Subject: FCC Class II Permission change for FCC ID: 2AIZN-YY5-X6855

This is to request a Class II permission change to our Mobile Phone; Model: X6855, FCC ID: 2AIZN-YY5-X6855, the device is identical to the previously certified except for the changes as below for details:

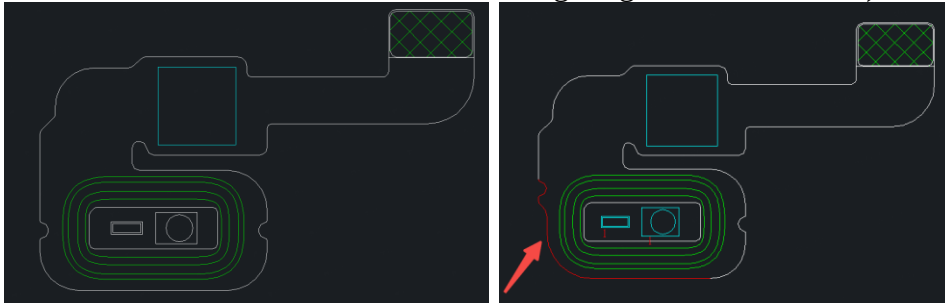
1. WPT Antenna: Enlarged appearance (The total length of the FPC dimensions is increased by 7.55mm, the width is increased by 10mm, and the charging power remains unchanged);
2. MINI LED FPC, Reduced appearance (Cut the red line pointed by the arrow 0.6mm inwards, which will not affect the lighting function or color.)
